Access Compliance Report Public Rights-of-Way (Curb Ramps)

Main Street: LAURINDA_WAY		Cross Street: E_SANTA_CLARA_AVE		Location:	NE
---------------------------	--	---------------------------------	--	-----------	----

ADA ID: RPAT211019092803	Ramp Type: Type 4 - Parallel	Initial Pass/Fail: Fail	Overall Compliance: No	Severity Score:	16
--------------------------	------------------------------	-------------------------	------------------------	-----------------	----

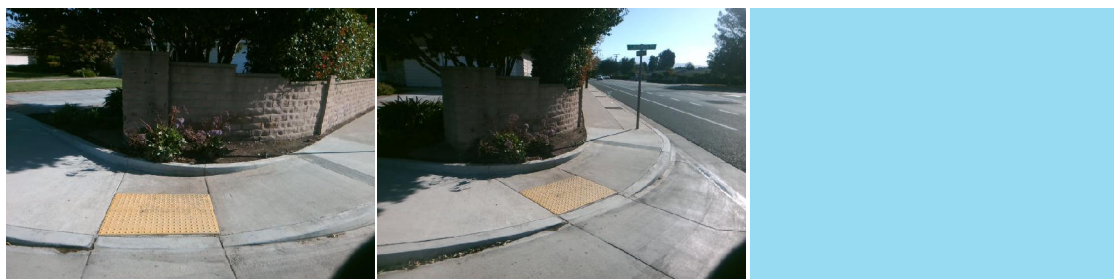
Compliance	Description	Data	Compliance	Description	Data
N/A	Ramp Length LT (in)	117	N/A	Ramp Length RT (in)	86
Yes	Ramp Width LT (in)	75	Yes	Ramp Width RT (in)	61
No	Ramp Run Slope LT (%)	8.4	Yes	Ramp Run Slope RT (%)	6.9
No	Ramp Cross Slope LT (%)	2.2	Yes	Ramp Cross Slope RT (%)	0.7
N/A	Landing Present	N/A	N/A	DWS Provided	N/A
N/A	Landing Length (in)	N/A	N/A	DWS Contrast	N/A
N/A	Landing Width (in)	N/A	N/A	DWS Length (in)	N/A
N/A	Landing Run Slope (%)	N/A	N/A	DWS Full Width	N/A
N/A	Landing Cross Slope (%)	N/A		DWS Offset Type	N/A
N/A	Landing Movement Obstructed?	N/A	N/A	DWS Offset Left (in)	N/A
	Landing Movement Type	N/A	N/A	DWS Offset Right (in)	N/A
N/A	Landing Shared	N/A			
N/A	Clear Space	Yes			
N/A	Clear Space To Crosswalk (in)	N/A			
N/A	Marked Crosswalk 1	No	N/A	Marked Crosswalk 2	No
	Crossing 1 Direction	W		Crossing 2 Direction	S
	Marked Crosswalk 1 Width (in)	N/A		Marked Crosswalk 2 Width (in)	N/A

Remove & Replace Curb Ramp With Two New Directional Ramps or Equivalent.

R304.3.2, R304.5.3, STD 1115
